AMENDMENTS TO DRAWINGS

REMARKS

Fig.2.

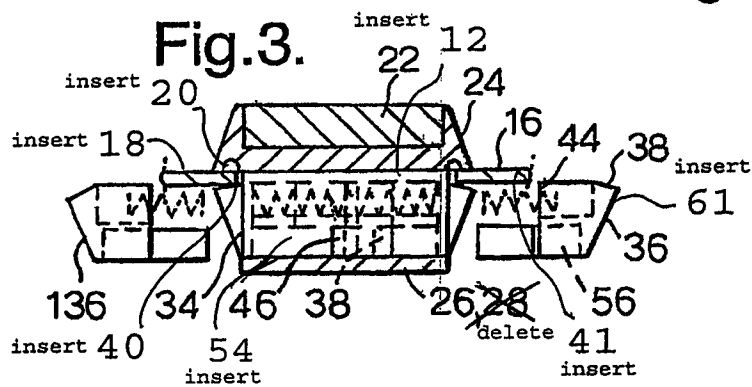
Fig. 2: 46

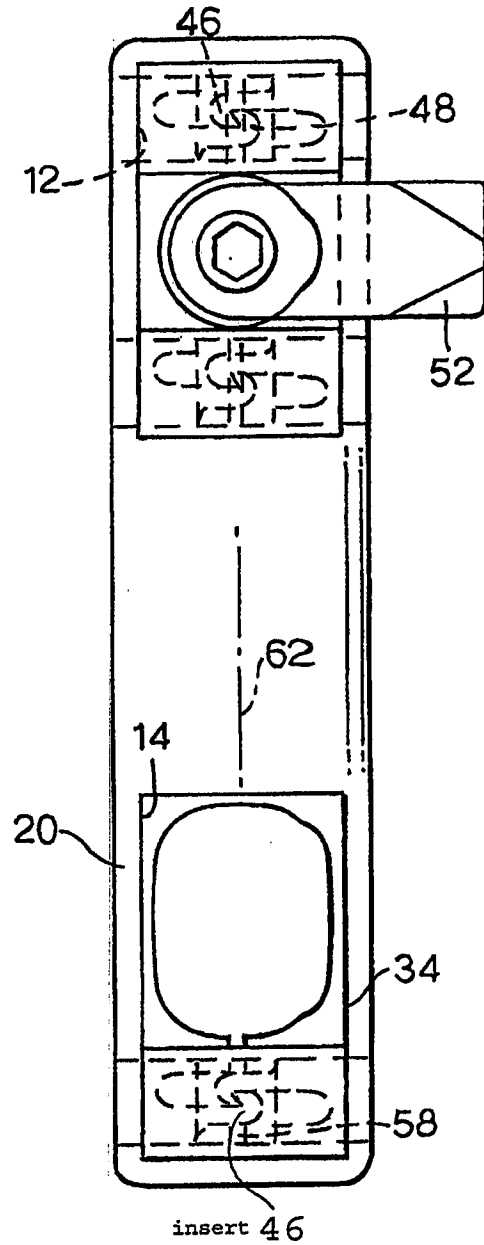
Fig. 3: 12, 18, 20, 40, 41, 54, 61

Further, Applicants remove reference number 28 from Fig. 3.

1. The opening (of claims 28 and 31) is shown at least by reference number 12 (see, e.g., Figure 3) and is described by the specification at least in the Abstract.

2. The rim of the opening (of claims 28 and 31) is shown at least by reference number 20 (see, e.g., Figure 3) and is described by the specification at least at in the Abstract.

3. The holding elements in a cylinder (of claims 28 and 31) is shown at least by reference number 36 (holding element) and 54 (cylinder) and is described by the specification at least at by paragraph [0013] of the application and was shown in original Figure 3.

5. The pin arrangement including screws (of claims 31 and 32) is shown at least by reference number 41 and is described by the specification at least at paragraph [0016] of application and shown in original Figure 3.

Fig.8A.

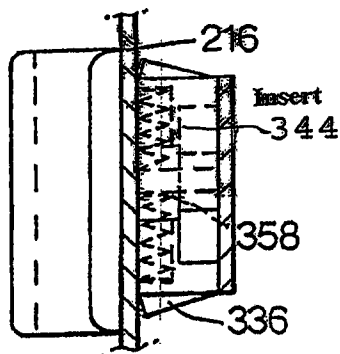
Fig. 8A: 344

Fig.8B.

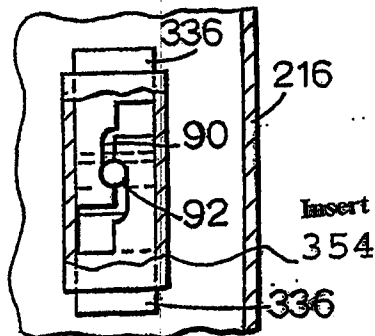
Fig. 8B: 354

Fig.21.

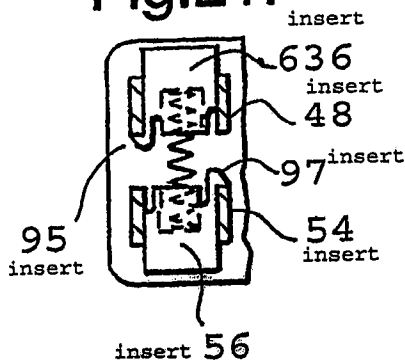
Fig. 21: 48, 54, 56, 95, 97, 636

4. The hook arrangement locking between the cylinder (of claim 29) is shown at least by reference number 97 (hook) and 54 (cylinder) and was shown in original Figure 21.

6. The undercut of the cylinder (of claim 34) is shown at least by reference number 95 (see, e.g., Figure 21) and is described at least by paragraph 17 of the application.
